APPLICATION FOR MODIFICATION ASSESSMENT REPORT

Application Number:	Mod2022/0096
----------------------------	--------------

Responsible Officer:	Alex Keller
Land to be developed (Address):	Lot 82 DP 5539, 3 Curl Curl Parade CURL CURL NSW 2096
Proposed Development:	Modification of Development Consent DA2020/1755 granted for demolition and construction of a dwelling house.
Zoning:	Warringah LEP2011 - Land zoned R2 Low Density Residential
Development Permissible:	Yes
Existing Use Rights:	No
Consent Authority:	Northern Beaches Council
Land and Environment Court Action:	No
Owner:	Jessie Hannah Mitchell Michael Alexander Nikotin
Applicant:	Trias Pty Ltd

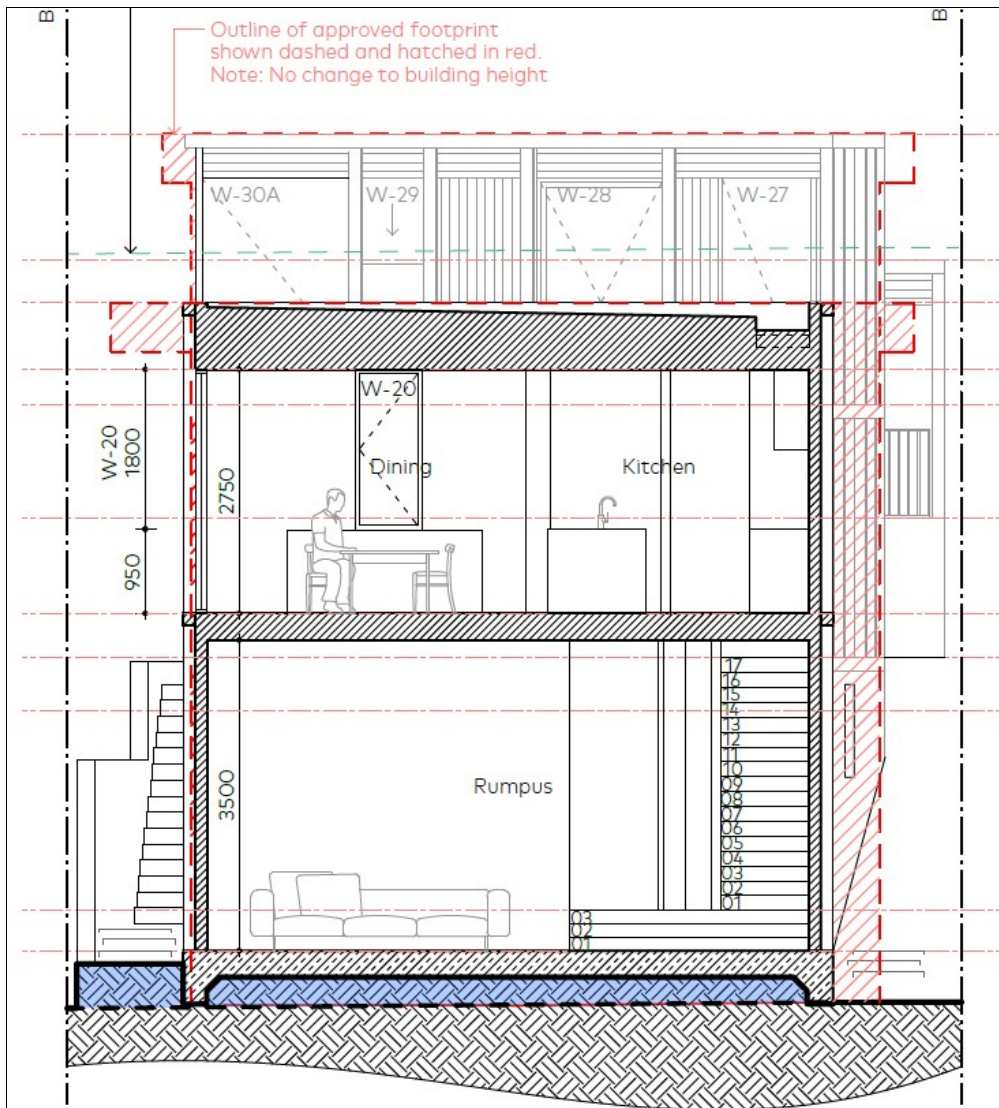
The building is of a contemporary style flat roof form has been used which is suitable for the location and consistent with other adjacent (newer) dwellings.

Image: Open style carport retained (using existing garage slab)

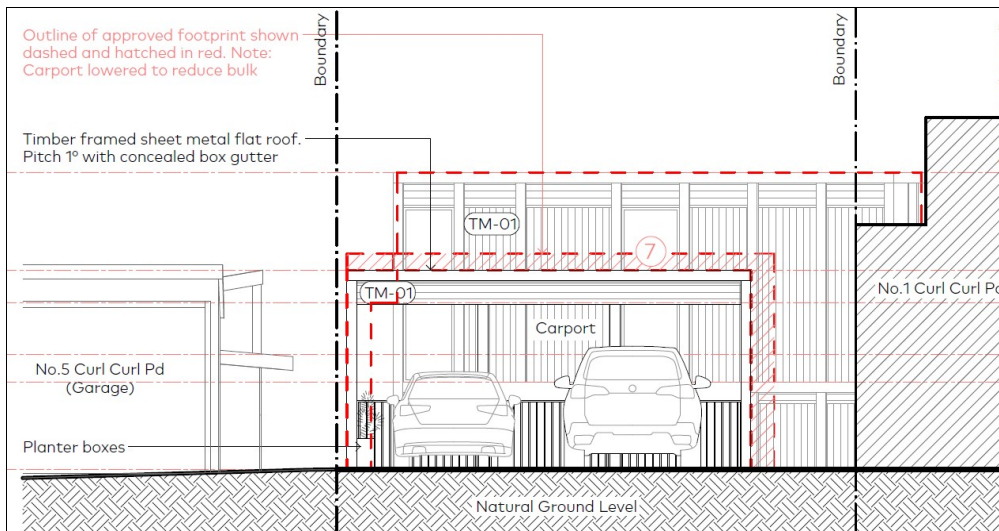
The modified proposal does not comply with the minimum side setback (0.9m) for the proposed carport structure. A setback of 150mm to 450mm is proposed along the western setback for the carport and side stairs within 1m of the boundary.

Image: Front setback encroachment changes.

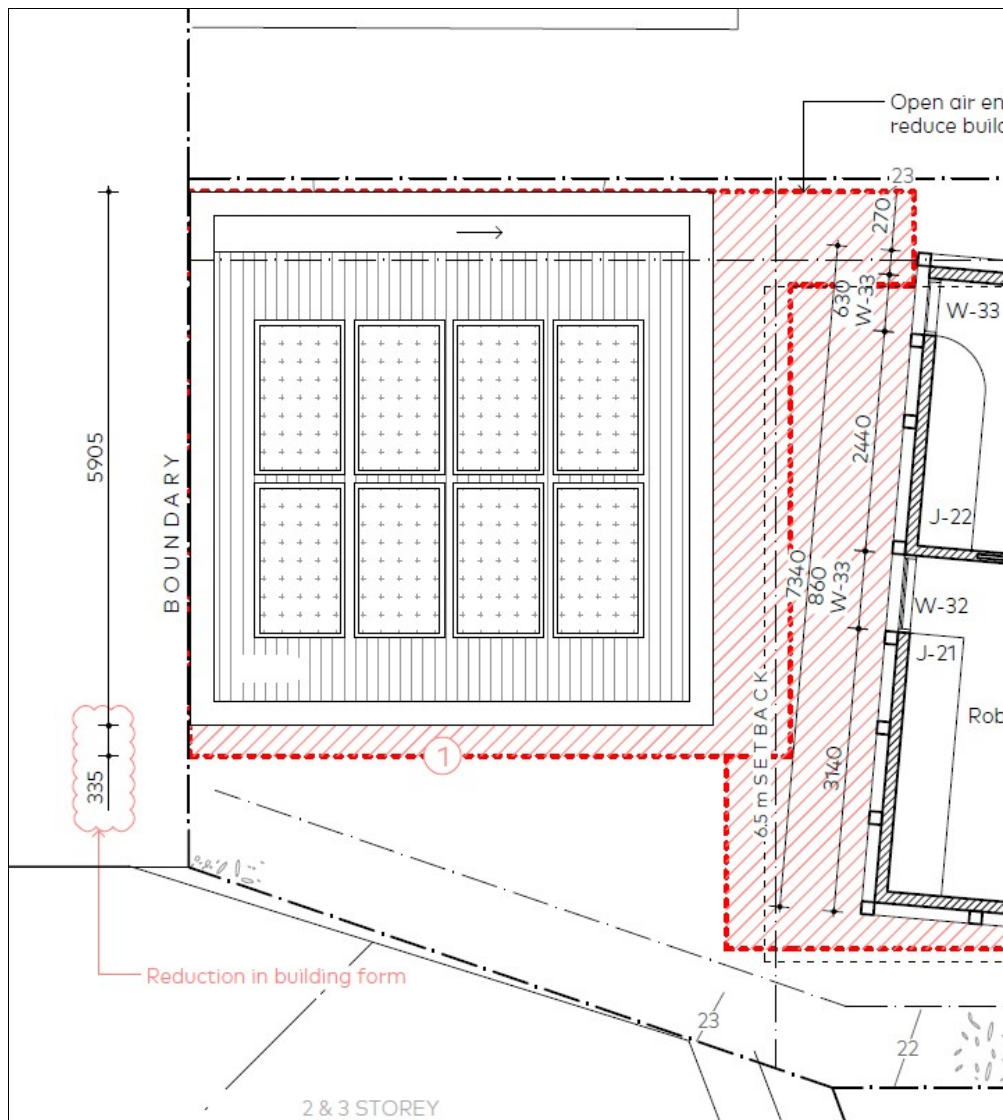
The proposal includes a reduction in the carport structure and maintains a variation to the front setback being forward of the 6.5m setback line as depicted in the image below:
